**LEBANON PLANNING BOARD  
MARCH 8, 2021 - 6:30 PM  
REMOTE VIA MICROSOFT TEAMS  
LEBANONNH.GOV/LIVE**

**Agenda  
Planning Board  
March 8, 2021**

Staff Memorandum – PB2021-02-EXT – *continued from 2/8/21*

EXISTING CONDITONS & DEMOLITION PLAN FOR  
**OCCOM PATH - BASIC HOLDINGS, LLC**  
OAK RIDGE ROAD, CITY OF LEBANON, GRAFTON COUNTY, NH

4  
SHEET 4 OF 17

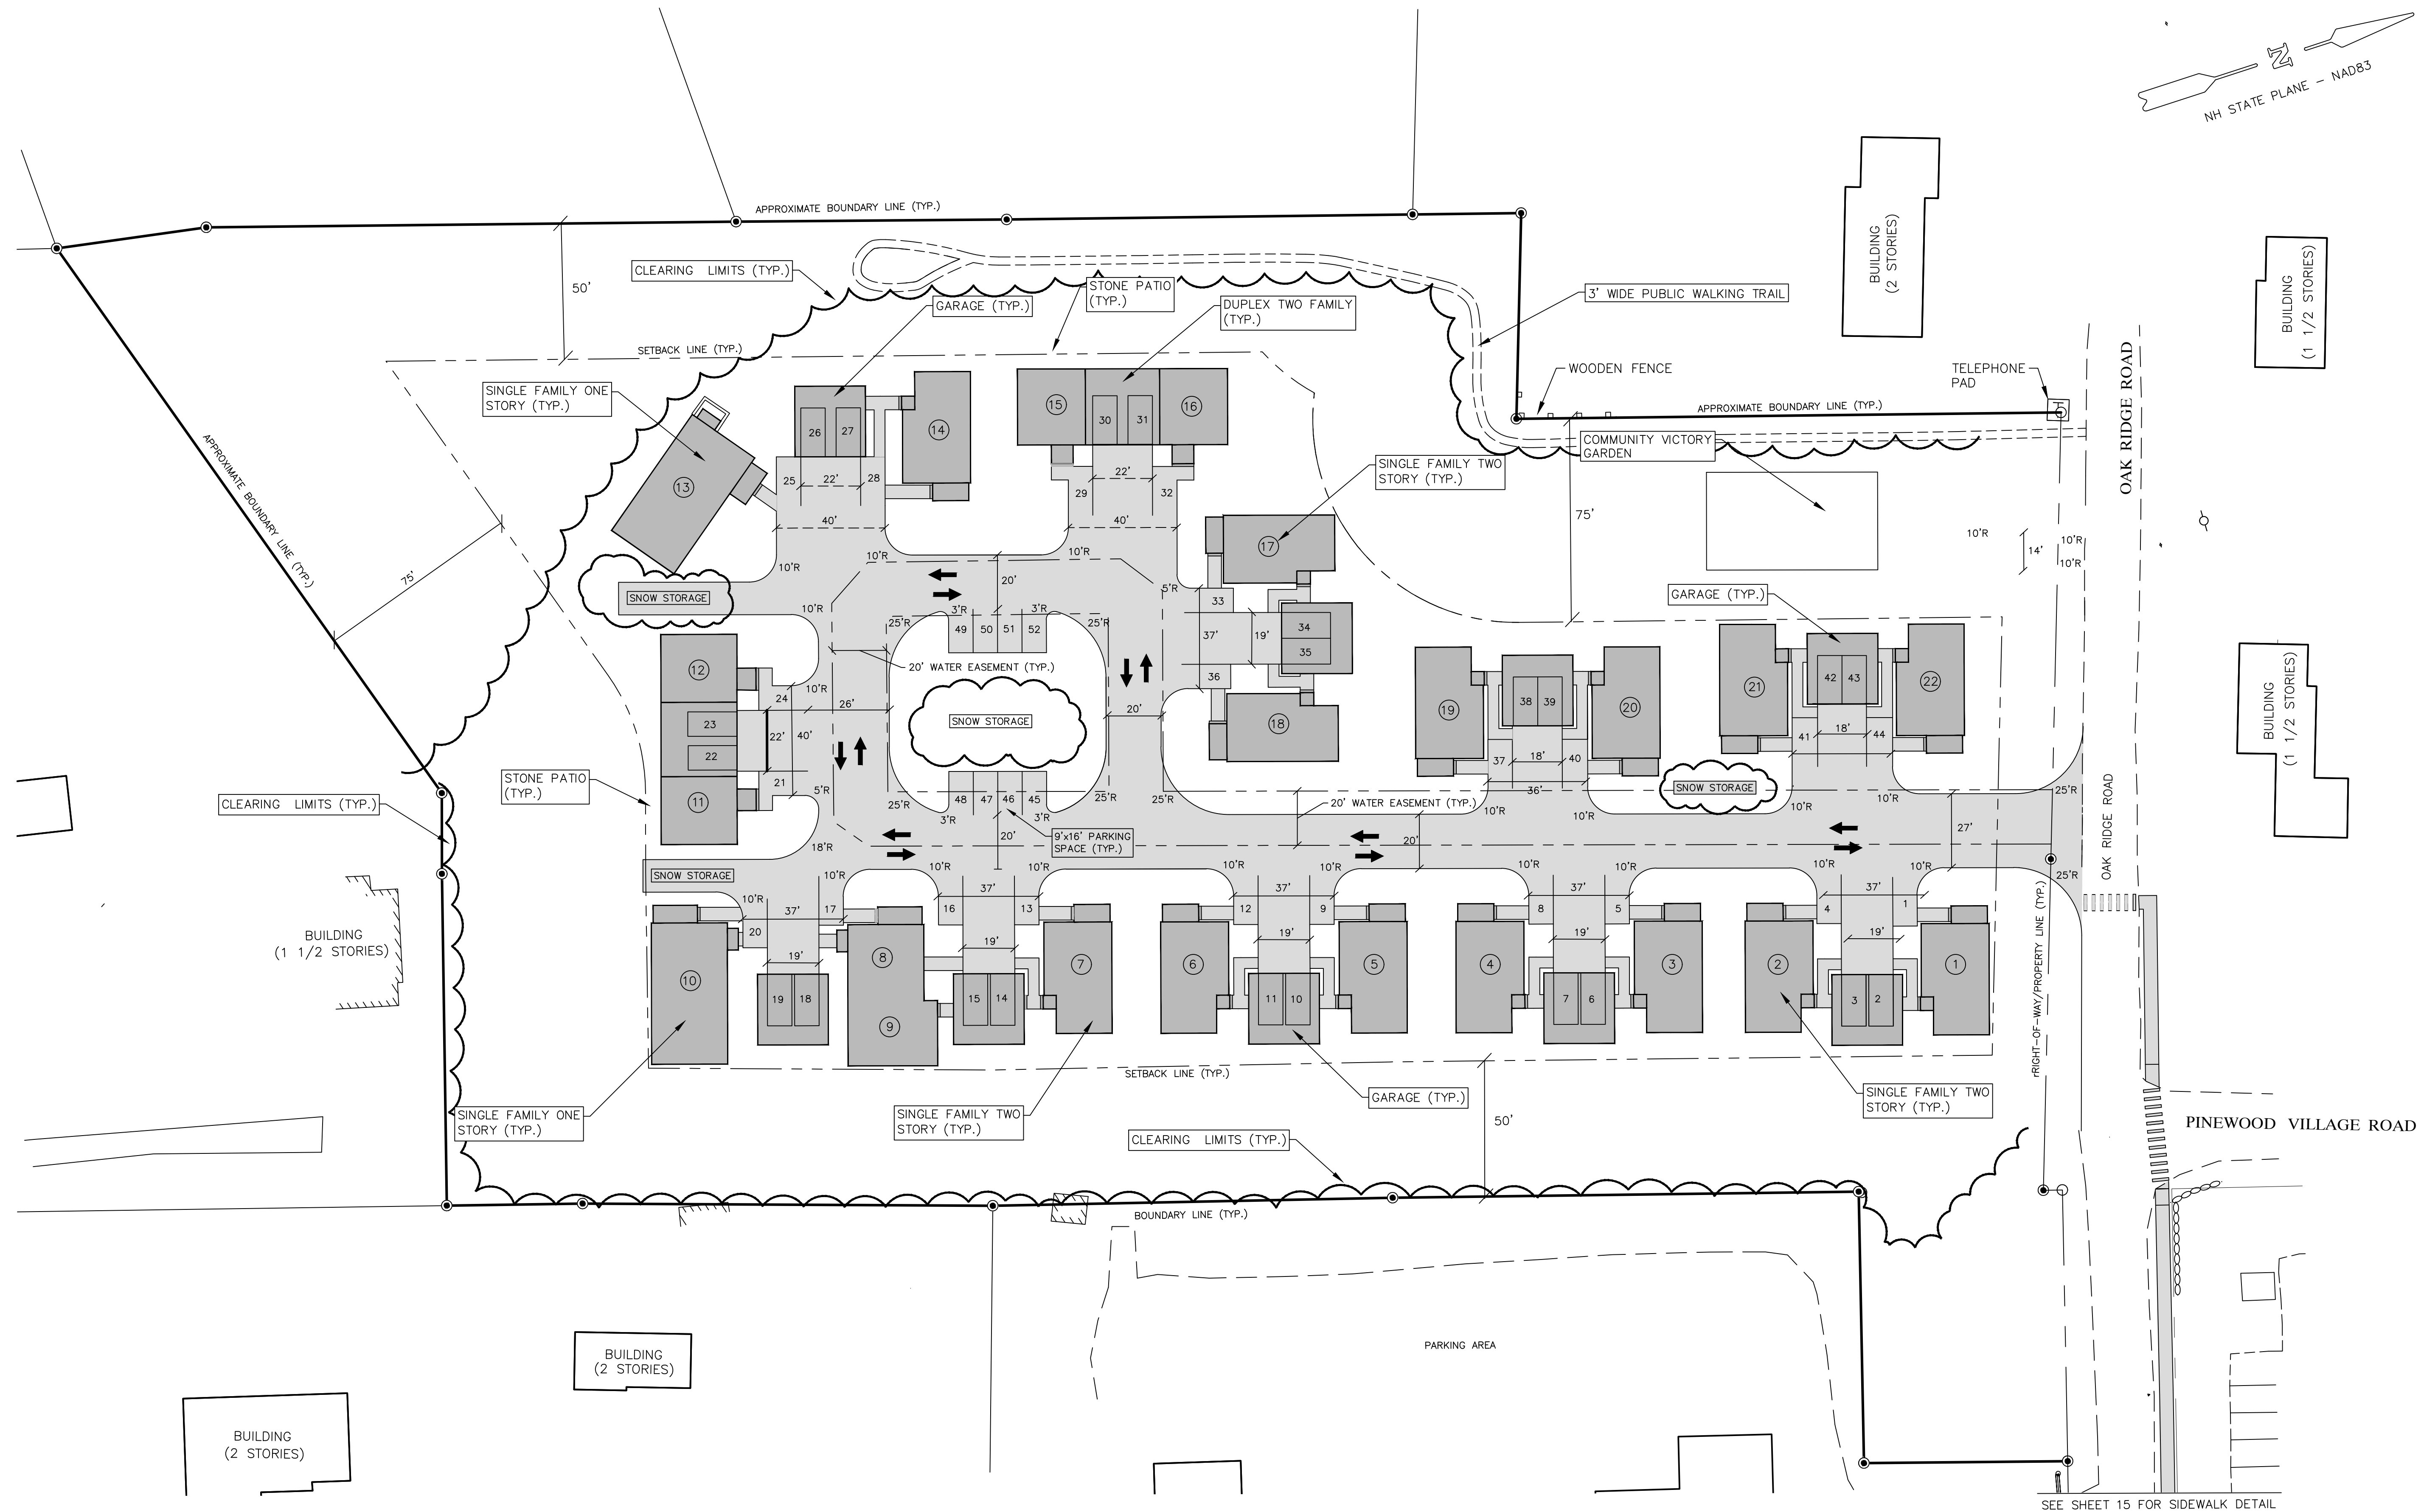
4. The project plans and application materials suggest the contemplated PURD is intended to be comprised of 22 dwelling units of varying style and dimension. Based upon inspection of site plan Sheets 2 and 4 it appears 21 units are proposed. We understand the eight-building planned on the southerly line of the proposed Access Drive, presently labeled as a "single family one-story" dwelling is actually intended to be a two-family residential structure. We recommend the drawings be revised accordingly.

3. We recommend the design engineer recheck and revise Sheet 4 to properly label: design radii of all pavement curves and flares; walkway width dimensions; and geometry of what appears to be driveway/parking accommodations for a "victory garden" planned at the northeast corner of the parcel.

GRADING, DRAINAGE & EROSION CONTROL PLAN FOR  
OCCOM PATH - BASIC HOLDINGS, LLC  
OAK RIDGE ROAD, CITY OF LEBANON, GRAFTON COUNTY, NH

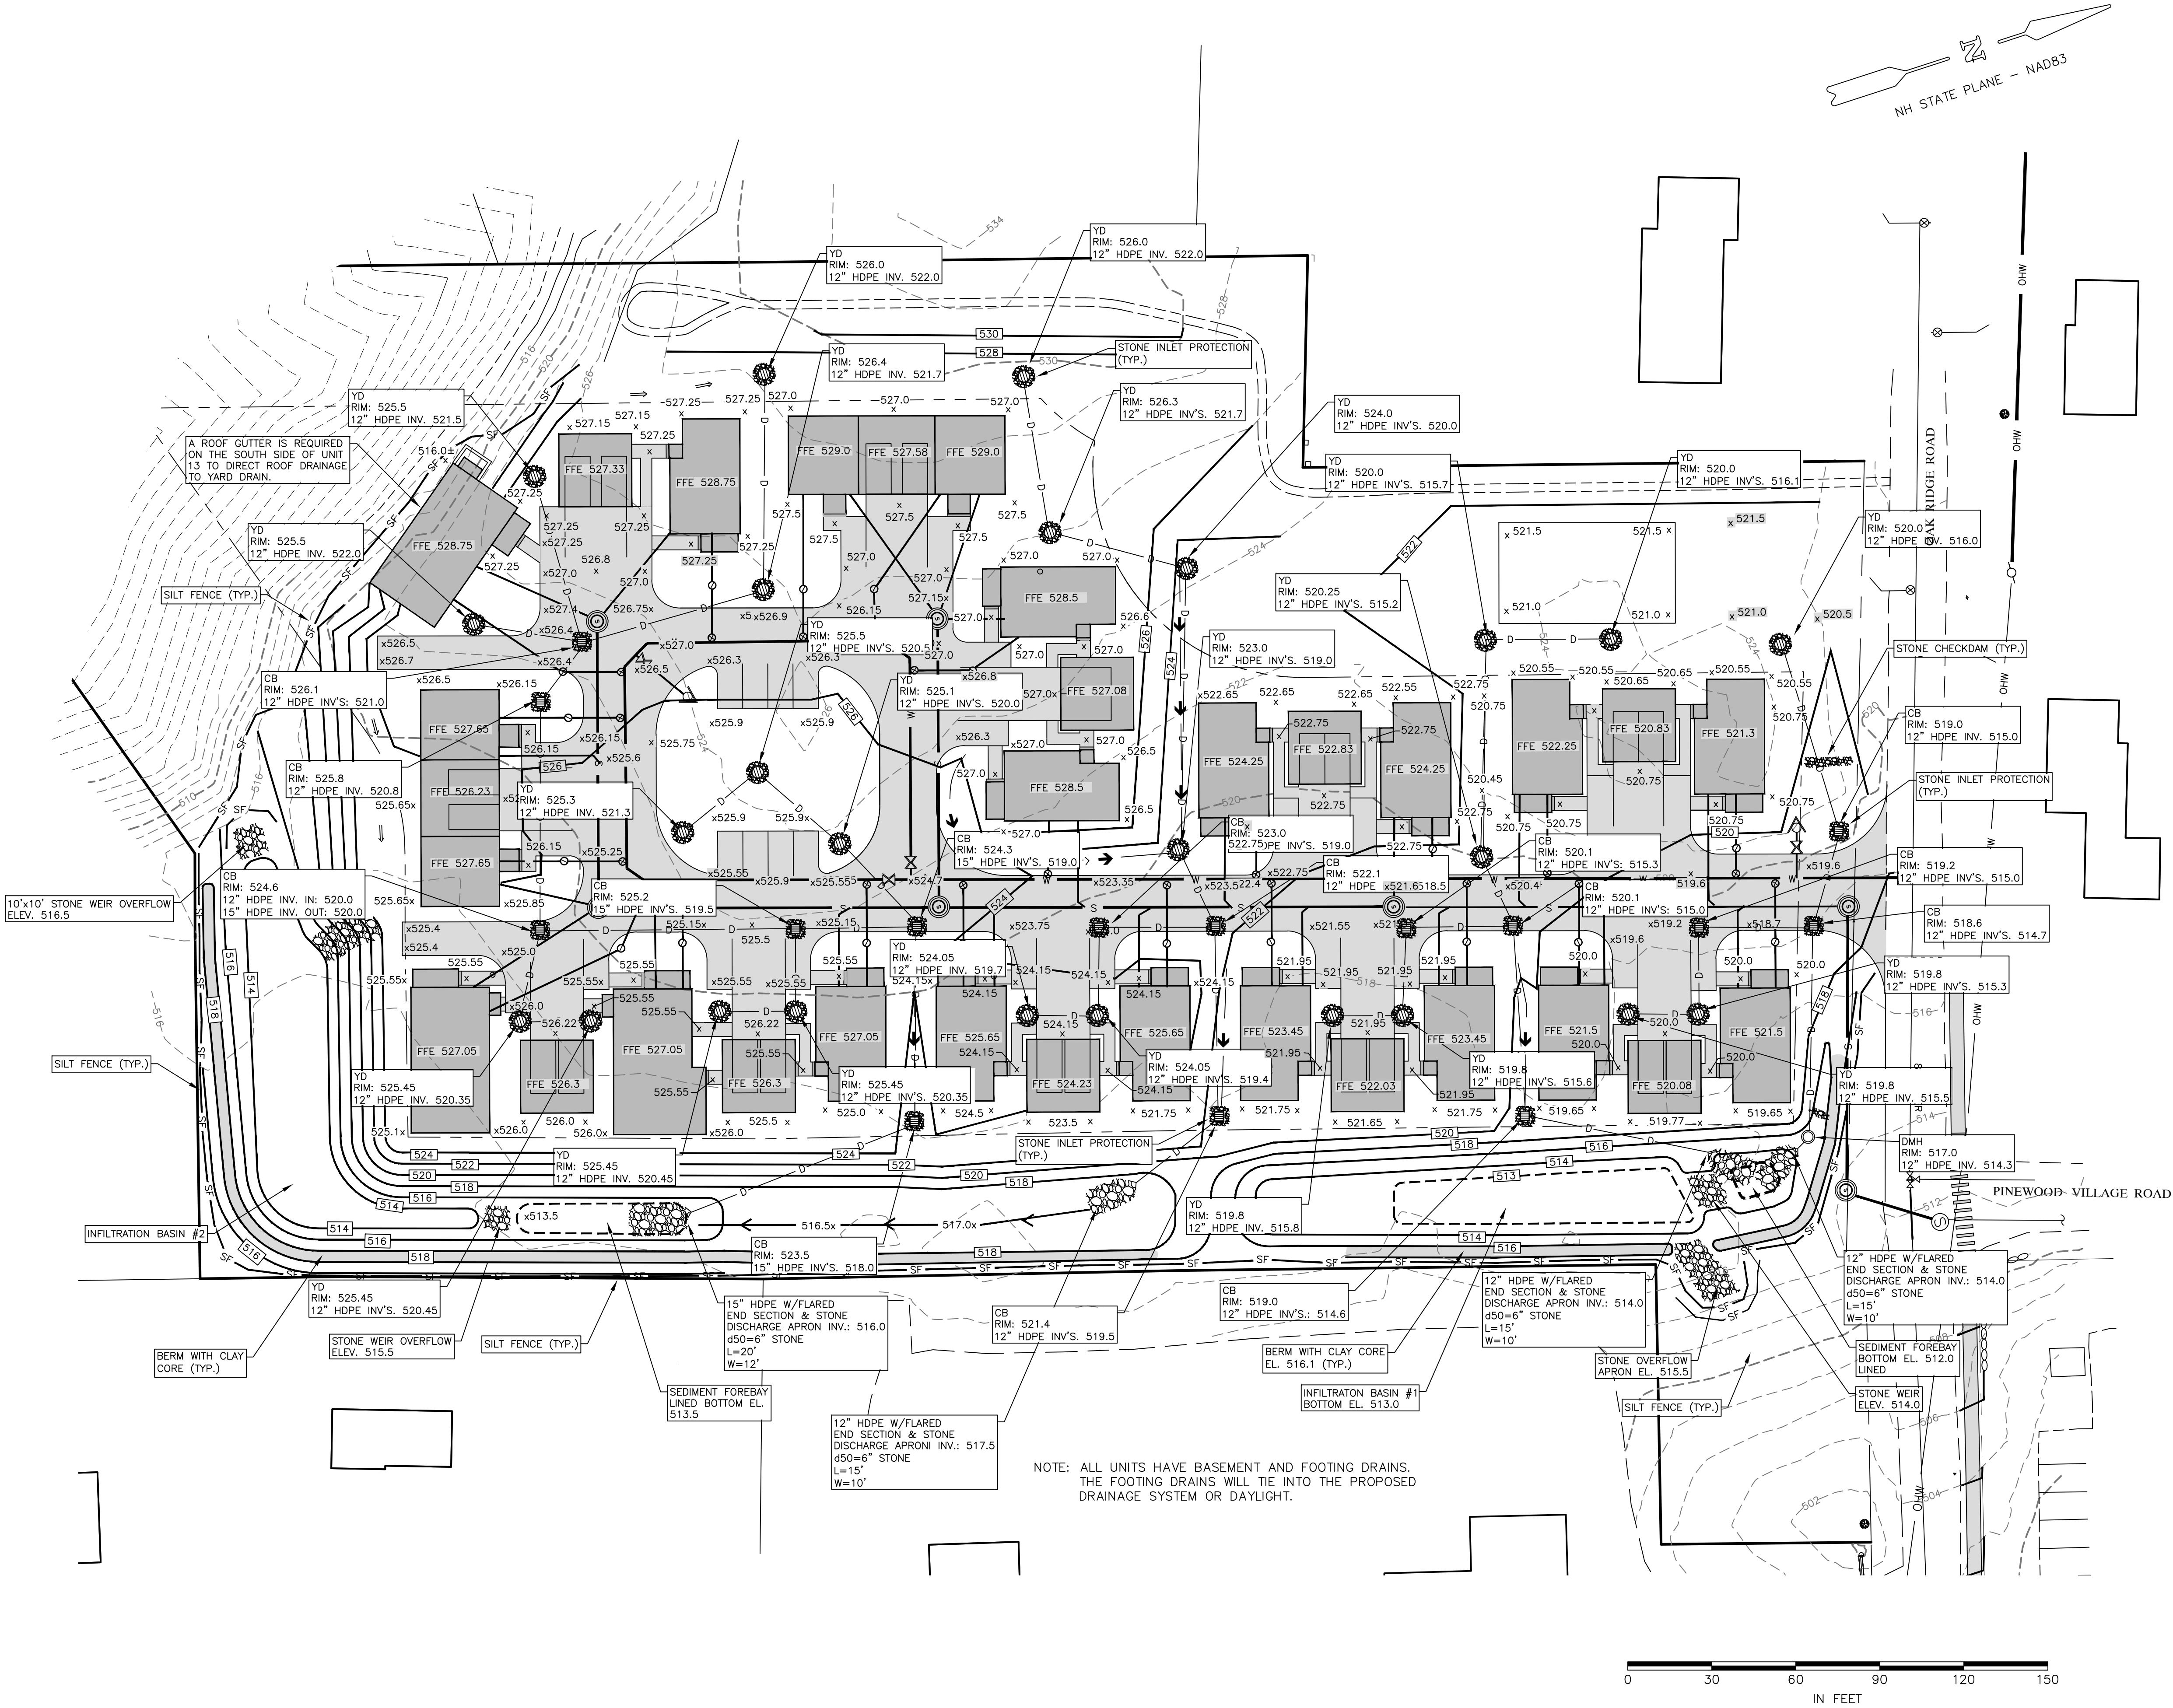
12. Sheet 7 depicts the location of a proposed hydrant situated beyond (in front of) proposed visitor parking. In order to help ensure this hydrant is visible, accessible and less susceptible to snow burial we recommend it be repositioned to a more conspicuous and convenient location.

13. Sheet 7 includes a note specifying intent to make connection with the City's fire alarm network at NH Route 10. We recommend the project plans be expanded to specify details of this planned installation.

14. Sheet 7 depicts a generalized layout of proposed underground electrical and telecommunications utility installations. We recommend the drawings be expanded to specify: (a) a typical cross-section of underground utility construction; (b) identify locations of proposed above ground transformer and pedestal installations; and (c) to indicate the manner and location at which future underground utility installations are to be connected with existing public utilities at Oak Ridge Road.
